**Project** 28 Lockwood Avenue, Belrose

**Report** BCA Assessment Report

**Reference** C21844-BCA Report-r2

**Date** 27 September 2022

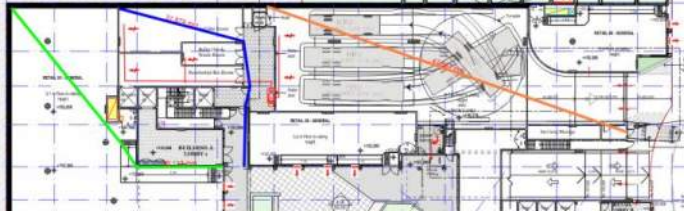
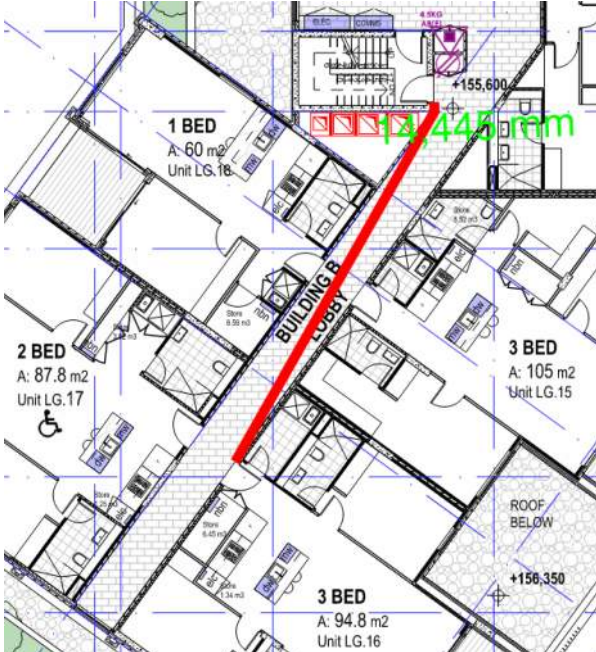
Clause	Comments	Assessment
<b>Part C1 – Fire Resistance and Stability</b>		
Spec C1.1      Roof lights 3.6	<p>The roof light must not be within 3m of another part of the building that projects beyond the roof unless that part of the building has the FRL required of a firewall, or within 3 m of any other roof light or the like in an adjoining SOU if the walls bounding the unit are required to have an FRL.</p> <p><b>Roof Lights</b>                      There are a eight roof lights that do not meet this concession of this clause. They are highlighted in the image below and are:</p> <ol style="list-style-type: none"> <li>1. Dark Green – Roof light to unit 1.06, 1800 mm from the solar panels</li> <li>2. Red - Roof light to unit 1.14, 2700 mm from the solar panels</li> <li>3. Pink - Roof lights (2) for units 1.05 and 1.14, 2400 mm from each other</li> <li>4. Blue - Roof light to unit 1.05, 2400 mm from the air-conditioning</li> <li>5. Orange - Roof light to unit 1.04, 450 mm from the air-conditioning</li> <li>6. Yellow - Roof light to unit 1.08, 1800 mm from the air-conditioning amd 1500 mm from the mechanical duct</li> <li>7. Light Green - Roof light to unit 1.11, 2100 mm from the air-conditioning</li> </ol>  <p><b>SOLUTION</b>                      These roof lights can be separated by 3 m or more to the requirements of this clause, or a Fire Engineer may be able to provide a Performance Solution</p>	<p style="color: red;">DNC/PS</p>

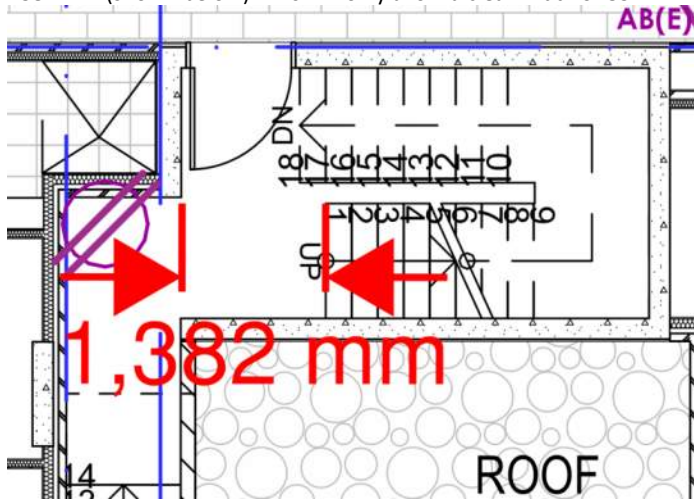
Clause	Comments	Assessment
<p>C3.2 Protection of openings in external walls</p>	<p>Openings in an external wall that is required to have an FRL must if the distance between the opening and the fire-source feature to which it is exposed is less than—</p> <ul style="list-style-type: none"> <li>(i) 3 m from a side or rear boundary of the allotment; or</li> <li>(ii) 6 m from the far boundary of a road, river, lake or the like adjoining the allotment, if not located in a storey at or near ground level; or</li> <li>(iii) 6 m from another building on the allotment that is not Class 10,</li> </ul> <p>be protected in accordance with C3.4 and if wall-wetting sprinklers are used, they are located externally.</p> <p><b>Retail 06</b> The retail tenancy at the eastern side of Glenrose Place has openings within approximately 1600 mm of the boundary where 3 m is the minimum required unless the window is protected by C3.4. This measurement is shown below:</p>  <p><b>SOLUTION</b> These openings must be protected in accordance with C3.4 or a Fire Engineering Performance Solution is required.</p>	<p>CRA/PS</p>

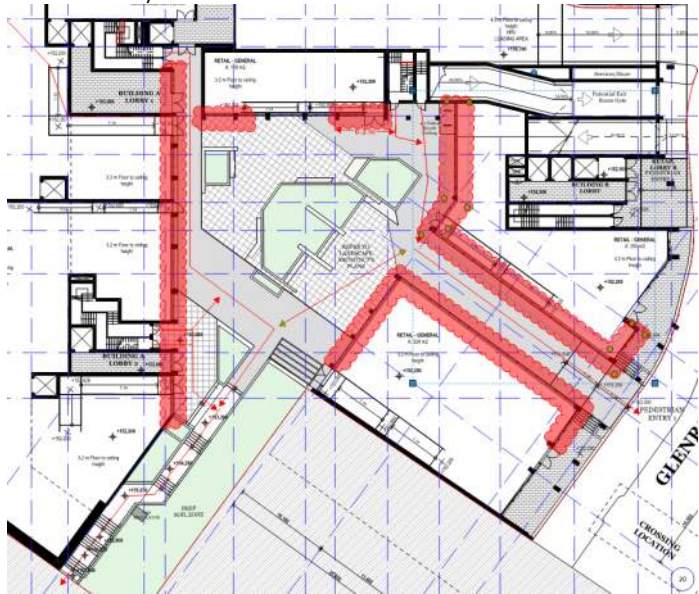
<b>Part D1 – Provisions for Escape</b>		
<p>D1.4 Exit travel distances</p>	<p>A summary of the maximum travel distances applicable to this building are (assuming a sprinkler system meeting the requirements of Specification E1.5a):</p> <ol style="list-style-type: none"> <li>1. Class 2 – SOU to exit (or point of choice) 12 m</li> <li>2. Class 2 common areas – 20 m to an exit or point of choice.</li> <li>3. Class 6 – 30 m to a single exit serving a storey at the level of access to a road or open space, or</li> <li>4. Class 6 – 20 m to a single exit, or a point of choice where two exits are available, in which case the maximum distance to one of those exits must not exceed 40 m.</li> <li>5. Class 7a – 20 m to a single exit or a point of choice where two exits are available, in which case the maximum distance to one of those exits must not exceed 40 m.</li> </ol> <p><b>Basement 02</b> Basement 02 has travel distances that are greater than allowed by this clause. These travel distances are shown in the figure below and are:</p> <ol style="list-style-type: none"> <li>1) <b>Retail 03</b> (shown in green) - Retail 03 has a travel distance of 36 m to a single exit at the level of access to a road or open space. This is greater than the 30 m maximum allowed.</li> <li>2) <b>Retail Bin Room</b> (shown in blue) – the retail bin room has a travel distance of 31.8 m to a single exit at the level of access to a road or open space. This is greater than the 30 m maximum allowed.</li> <li>3) <b>Loading Dock</b> (shown in orange) – the loading dock has a travel distance of 44 m to a single exit at the level of access to a road or open space. This is greater than the 30 m maximum allowed.</li> </ol>	<p>DNC/PS</p>

Clause	Comments	Assessment
	 <p><b>Lower Ground</b></p> <p>Lower ground, Units LG.16 and LG.17 have a travel distance from the SOU doorway to a single exit of 14.4 m and 14.1 respectively. This is greater than the 12 m maximum allowed. The image below shows the 14.4 m travel distance for LG.16.</p>  <p><b>Ground Level:</b></p> <p>Ground level has multiple travel distances greater than allowed:</p> <ol style="list-style-type: none"> <li>1) Unit G.05 has a travel distance from the SOU doorway to a single exit of 15.7 m (shown below in red)</li> <li>2) Unit G.13 has a travel distance from the SOU doorway to a single exit of 13.8m. (shown below in blue)</li> <li>3) Unit G.14 has a travel distance from the SOU doorway to a single exit of 14.4 m (shown below in green).</li> </ol> <p>These travel distances are greater than the 12 m maximum allowed to a single exit.</p>

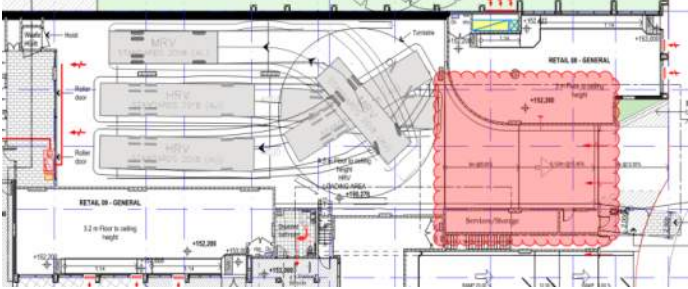
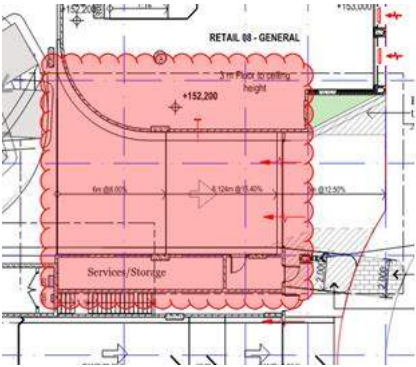
Clause	Comments	Assessment
	 <p><b>Level 1</b>                      Level 1, Unit 1.09, has a travel distance from the SOU doorway to a single exit of 15 m (shown below in blue). This is greater than the 12 m maximum allowed.                      Level 1, Communal Open Space, has a travel distance to a single exit of 32.8 m (shown below is red). This is greater than the 20 m maximum allowed.</p>  <p><b>SOLUTION</b>                      Amended plans may resolve some issues and a Fire Engineer may be able to justify the remaining extended travel distances in a Performance Solution.</p>	
<p>D1.6 Dimensions of exits and paths of travel to exits</p>	<p>The stair widths may need to be widened to provide 1m clear widths.</p> <p>Please note a constructed width of approximately 1,100mm is required to install a compliant handrail to one (1) side of a stairway (as required for a fire-isolated stairway), and a constructed width of approximately 1,200mm is required to install compliant handrails to both sides of a stairway (as required for a non-fire-isolated stairway).</p> <p>Termination of handrails must be considered in the design (see part 5.5 of this report).</p> <p><b>Basement 04 fire-isolated stairway –</b>                      Three of the four fire-isolated stairway have will have issues with travel width when correct handrail terminations are provided. These are the southwest, north central and southeast fire-isolated stairway. These stairways are highlighted in red below:</p>	<p>DNC</p>

Clause	Comments	Assessment
	 <p>There is insufficient room to provide a 1m clear width to the fire hydrant when a compliant handrail is installed. A compliant handrail must continue one tread beyond the bottom riser and then 300 mm horizontal. This requires a space of <math>1000 + 250 + 300 = 1550</math> mm. As shown above only 1390 mm is provided to these three fire-isolated stairways. This will only provide a travel width of 880 mm which is less than the 1m minimum required.</p> <p><b>Residential fire-isolated stairway –</b>                  The southwest and northwest residential fire-isolated stairways have insufficient room to provide a 1m clear width when a compliant handrail is installed. A compliant handrail must continue one tread beyond the bottom riser and then 300 mm horizontal. This requires a space of <math>1000 + 250 + 300 = 1550</math> mm.                  The southwest residential fire-isolated stairway is only provided with 1140 mm (shown below). This will only allow a clear width of 590 mm.</p>

Clause	Comments	Assessment
	<p>The northwest residential fire-isolated stairway is only provided with 1382 mm (shown below). This will only allow a clear width of 832 mm.</p>  <p><b>SOLUTION</b></p> <p>All stairway designs should be revisited and the location of a compliant handrail should be detailed. Please review figures in section 5.5 of this report and review each handrail design so adequate space in the stairs is provided.</p>	
<p>D1.7 Travel via fire-isolated exits</p>	<p>A doorway from a room must not open directly into a stairway, passageway or ramp that is required to be fire-isolated unless it is from—</p> <ol style="list-style-type: none"> <li>1. a public corridor, public lobby or the like; or</li> <li>2. a sole-occupancy unit occupying all of a storey; or</li> <li>3. a sanitary compartment, airlock or the like.</li> </ol> <p>Each fire-isolated stairway or fire-isolated ramp must provide independent egress from each storey served and discharge directly, or by way of its own fire-isolated passageway—</p> <ol style="list-style-type: none"> <li>1. to a road or open space; or</li> <li>2. to a point—             <ul style="list-style-type: none"> <li>(A) in a storey or space, within the confines of the building, that is used only for pedestrian movement, car parking or the like and is open for at least 2/3 of its perimeter; and</li> <li>(B) from which an unimpeded path of travel, not further than 20 m, is available to a road or open space; or</li> </ul> </li> <li>3. into a covered area that—             <ul style="list-style-type: none"> <li>(A) adjoins a road or open space; and</li> <li>(B) is open for at least 1/3 of its perimeter; and</li> <li>(C) has an unobstructed clear height throughout, including the perimeter openings, of not less than 3 m; and</li> <li>(D) provides an unimpeded path of travel from the point of discharge to the road or open space of not more than 6 m.</li> </ul> </li> </ol> <p><b>Discharging internally</b></p> <p>There are multiple fire-isolated exits that do not provide egress directly to open space or alternative covered areas as allowed by this clause. These fire-isolated exits are</p> <ol style="list-style-type: none"> <li>1. the southwest residential fire-isolated stairway,</li> <li>2. the southwest basement fire-isolated stairway,</li> <li>3. the central north residential fire-isolated stairway,</li> <li>4. the central north basement fire-isolated stairway,</li> </ol>	<p>DNC/PS</p>

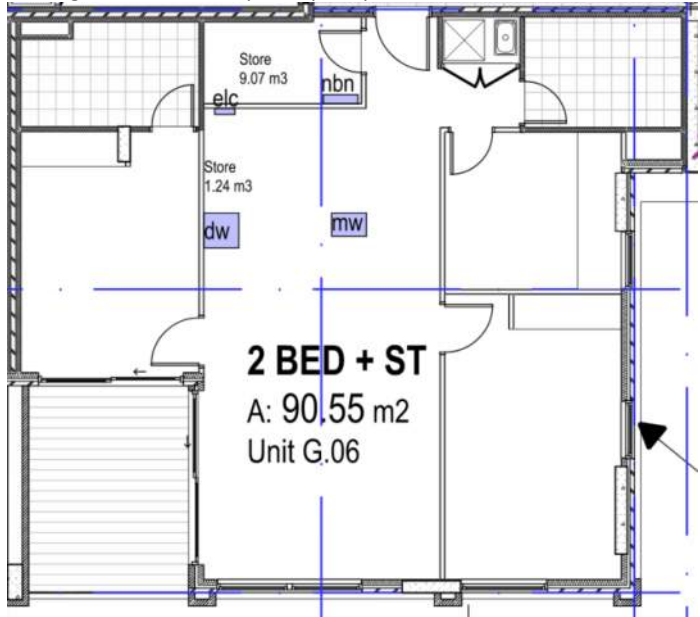
<b>Part D2 – Construction of Exits</b>		
D2.10 Pedestrian ramps	(a) A fire-isolated ramp may be substituted for a fire-isolated stairway if the construction enclosing the ramp and the	DNC

Clause	Comments	Assessment
	<p>width and ceiling height comply with the requirements for a fire-isolated stairway.</p> <p>(b) A ramp serving as a required exit must—</p> <ul style="list-style-type: none"> <li>(i) where the ramp is also serving as an accessible ramp under Part D3, be in accordance with AS 1428.1; or</li> <li>(ii) in any other case, have a gradient not steeper than 1:8.</li> </ul> <p>(c) The floor surface of a ramp must have a slip-resistance classification not less than that listed in Table D2.14 when tested in accordance with AS 4586.</p> <p><b>Ramp serving loading dock exit:</b> The ramp serving the loading dock exit is both steeper than allowed by AS1428.1 and also steeper than 1:8 (12.5%). The ramp provided is 15.4%. Also this gradient is provided to the landing of the doorway to the exit as a cross fall (see D2.15)</p>  <p><b>SOLUTION</b> Adjust the doorway location to avoid being located on a ramp.</p>

FIGURE 26(C) STAIR HANDRAILS—HANDRAIL TERMINATIONS

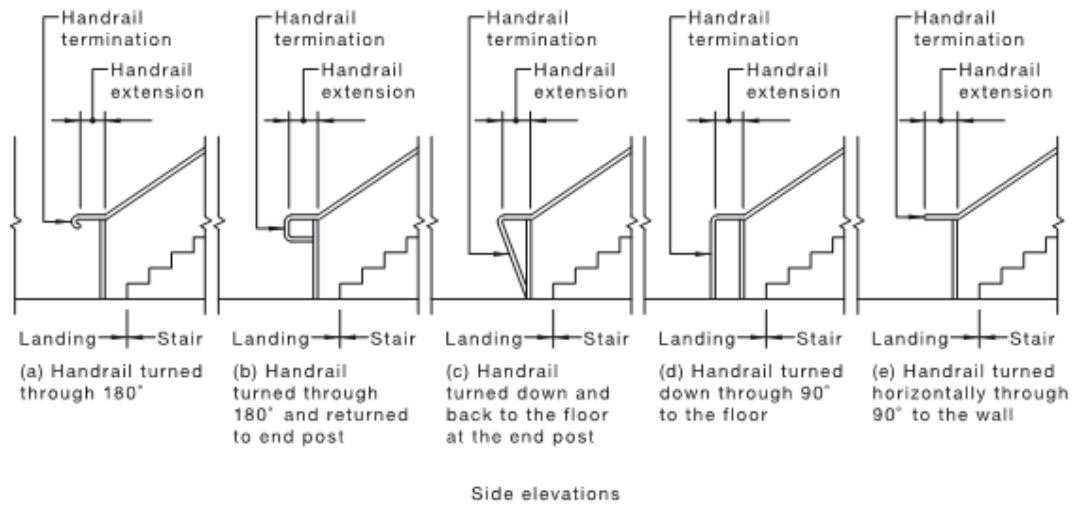
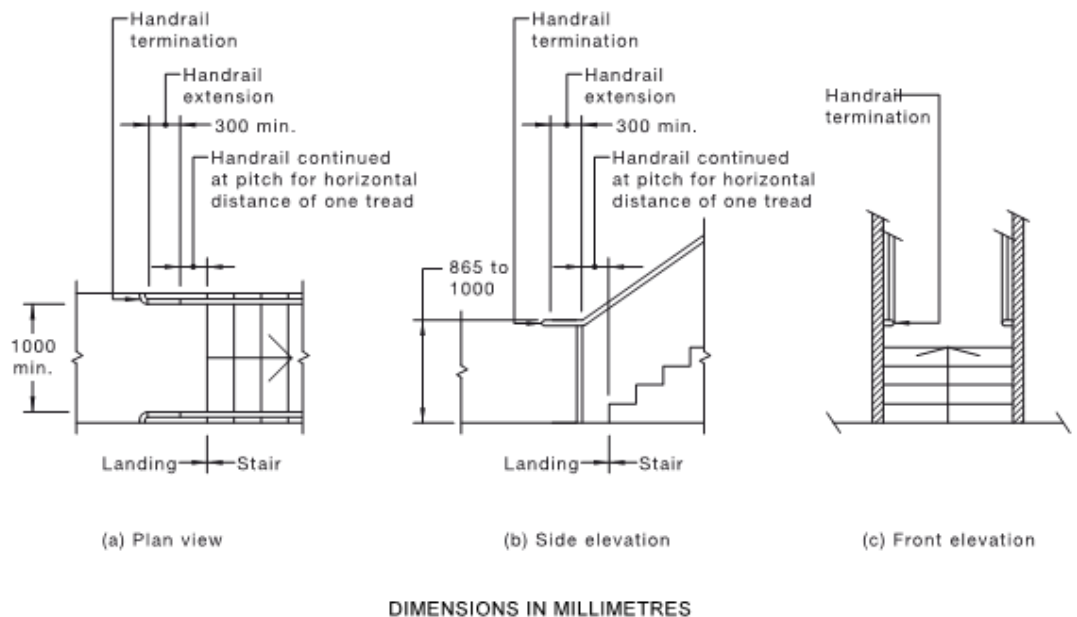
Ensure that the fire-isolated stairways have the stair set backs at the bottom of a stair flight as per Figure 26 of AS1428.1-2009 to ensure that the handrails maintain a consistent height.

The bottom of the fire-isolated stairways are to be provided with handrail extensions representing one treads length on the angle, plus 300mm horizontally plus a turn down. The one treads length is required to extend straight out from the stairs in line with the direction of the stairs. Please show the handrail extensions.

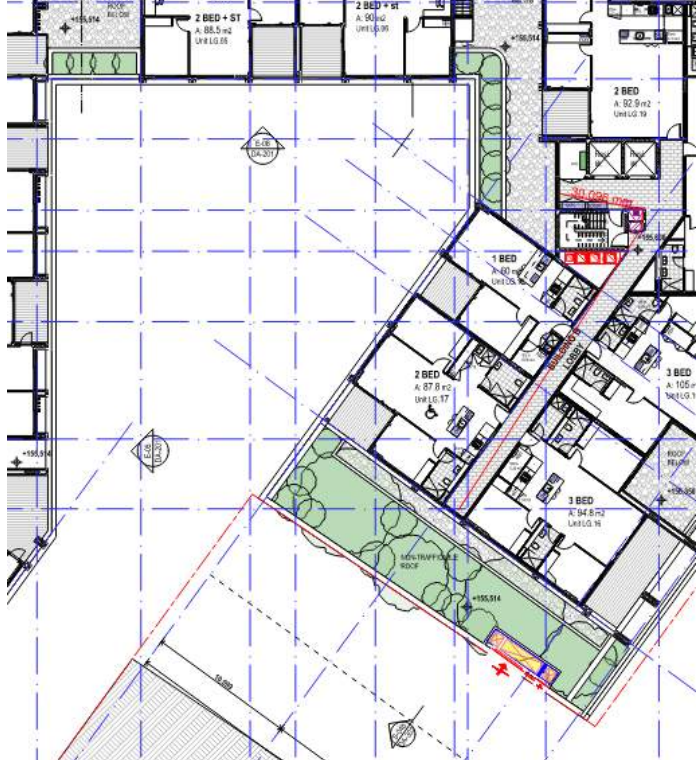
Clause	Comments	Assessment
	This requires the floor between the retail and residential parts to achieve a FRL of 180/180/180 above the commercial/retail tenancy and associated loading dock.	
C2.10	Separation of lift shafts Any lift that connects more than three storeys must be enclosed within a shaft that has the FRLs outlined in Specification C1.1 with reference to the classification in which it is located. Openings for lift landing doors and services must be protected in accordance with the Deemed-to-Satisfy Provisions of Part C3.	CRA
C2.11	Stairways and lifts in one shaft The fire-isolated stairways and the lifts are in separate shafts.	CRA
C2.12	Separation of equipment Equipment including lift motor rooms, emergency generators sustaining emergency equipment operating in emergency mode, central smoke control plant, boilers or battery areas with a voltage exceeding 24 volts and a capacity exceeding 10 ampere hours are to be fire separated from the remainder of the building in accordance with this Clause.	CRA

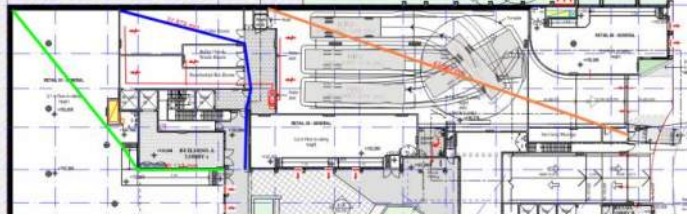
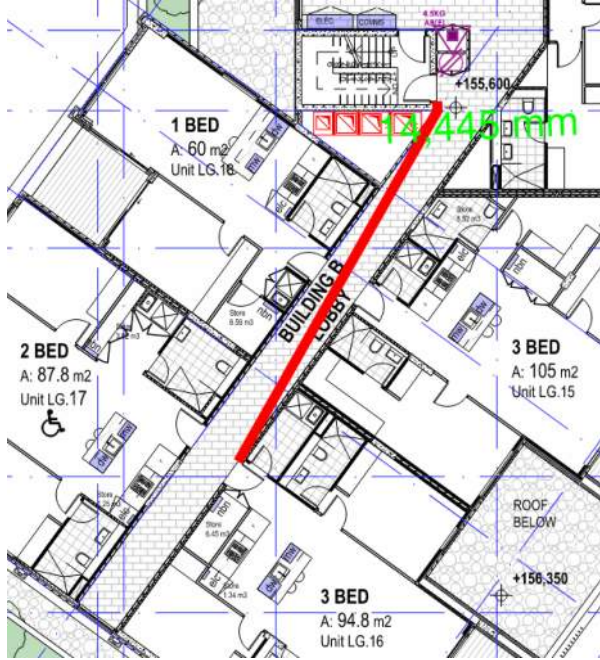
<p>3.6      Rooflights</p>	<p>The roof light must not be within 3m of another part of the building that projects beyond the roof unless that part of the building has the FRL required of a firewall, or within 3 m of any other roof light or the like in an adjoining SOU if the walls bounding the unit are required to have an FRL.</p> <p><b>Roof Lights</b>                  There are a eight roof lights that do not meet this concession of this clause. They are highlighted in the image below and are:</p> <ol style="list-style-type: none"> <li>8.    Dark Green – Roof light to unit 1.06, 1800 mm from the solar panels</li> <li>9.    Red - Roof light to unit 1.14, 2700 mm from the solar panels</li> <li>10.   Pink - Roof lights (2) for units 1.05 and 1.14, 2400 mm from each other</li> <li>11.   Blue - Roof light to unit 1.05, 2400 mm from the air-conditioning</li> <li>12.   Orange - Roof light to unit 1.04, 450 mm from the air-conditioning</li> <li>13.   Yellow - Roof light to unit 1.08, 1800 mm from the air-conditioning amd 1500 mm from the mechanical duct</li> <li>14.   Light Green - Roof light to unit 1.11, 2100 mm from the air-conditioning</li> </ol>	<p>DNC/PS</p>

Clause	Comments	Assessment
	 <p><b>SOLUTION</b> These roof lights can be separated by 3 m or more to the requirements of this clause, or a Fire Engineer may be able to provide a Performance Solution</p>	
3.7	Internal columns and walls: Concession	CRA
3.8	Open spectator stands and indoor sports stadiums: Concession	NA
3.9	Carparks	Noted
3.10	Class 2 and 3 buildings: Concession	NA
<b>Specification C1.8 – Structural Tests for Lightweight Construction</b>		
1	Scope	Noted
2	Application	Noted
3	Tests	CRA
4	Test Specimens	CRA
5	Test methods	CRA
6	Criteria for compliance	CRA
<b>Specification C1.10 – Fire Hazard Properties</b>		
1	Scope	Noted
2	Application	Noted
3	Floor linings and floor coverings	CRA
4	Wall and ceiling linings	CRA
5	Air-handling ductwork	CRA
6	Lift cars	CRA
7	Other materials	CRA
<b>Specification C1.11 – Performance of External Walls in a Fire</b>		
1	Scope	Noted

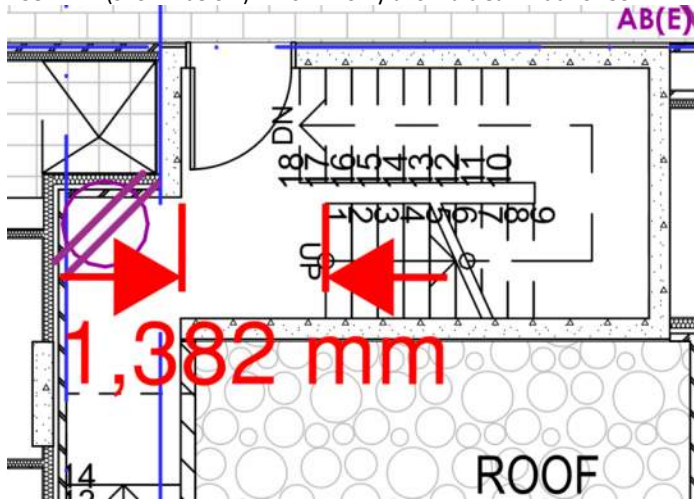
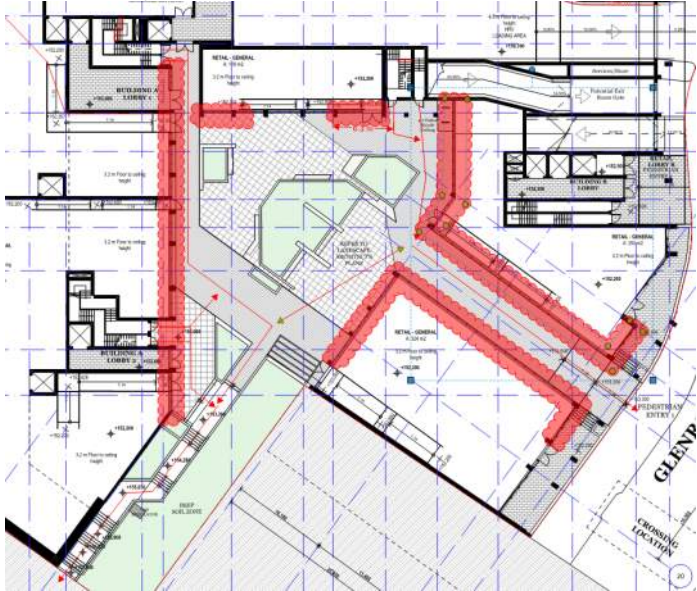
Clause	Comments	Assessment	
<b>Part D1 – Provisions for Escape</b>			
D1.0	DTS Provisions	Information only.	Noted
D1.1	Application of Part	Information only.	Noted
D1.2	Number of exits required	At least one exit from each storey and two from the basement (rise greater than 1.5 m).	CRA
D1.3	When fire-isolated stairways and ramps are required	All stairways in the class 2 part, not within SOU, are required to be fire-isolated. All stairways in class 7a part are required to be fire-isolated.	CRA
D1.4	Exit travel distances	<p>A summary of the maximum travel distances applicable to this building are (assuming a sprinkler system meeting the requirements of Specification E1.5a):</p> <ol style="list-style-type: none"> <li>6. Class 2 – SOU to exit (or point of choice) 12 m</li> <li>7. Class 2 common areas – 20 m to an exit or point of choice.</li> <li>8. Class 6 – 30 m to a single exit serving a storey at the level of access to a road or open space, or</li> <li>9. Class 6 – 20 m to a single exit, or a point of choice where two exits are available, in which case the maximum distance to one of those exits must not exceed 40 m.</li> <li>10. Class 7a – 20 m to a single exit or a point of choice where two exits are available, in which case the maximum distance to one of those exits must not exceed 40 m.</li> </ol> <p><b>Basement 02</b> Basement 02 has travel distances that are greater than allowed by this clause. These travel distances are shown in the figure below and are:</p> <ol style="list-style-type: none"> <li>4) <b>Retail 03</b> (shown in green) - Retail 03 has a travel distance of 36 m to a single exit at the level of access to a road or open space. This is greater than the 30 m maximum allowed.</li> <li>5) <b>Retail Bin Room</b> (shown in blue) – the retail bin room has a travel distance of 31.8 m to a single exit at the level of access to a road or open space. This is greater than the 30 m maximum allowed.</li> </ol>	DNC/PS

Clause	Comments	Assessment
	<p>6) <b>Loading Dock</b> (shown in orange) – the loading dock has a travel distance of 44 m to a single exit at the level of access to a road or open space. This is greater than the 30 m maximum allowed.</p>  <p><b>Lower Ground</b>                  Lower ground, Units LG.16 and LG.17 have a travel distance from the SOU doorway to a single exit of 14.4 m and 14.1 respectively. This is greater than the 12 m maximum allowed. The image below shows the 14.4 m travel distance for LG.16.</p>  <p><b>Ground Level:</b>                  Ground level has multiple travel distances greater than allowed:</p> <ul style="list-style-type: none"> <li>4) Unit G.05 has a travel distance from the SOU doorway to a single exit of 15.7 m (shown below in red)</li> <li>5) Unit G.13 has a travel distance from the SOU doorway to a single exit of 13.8m. (shown below in blue)</li> <li>6) Unit G.14 has a travel distance from the SOU doorway to a single exit of 14.4 m (shown below in green).</li> </ul> <p>These travel distances are greater than the 12 m maximum allowed to a single exit.</p>
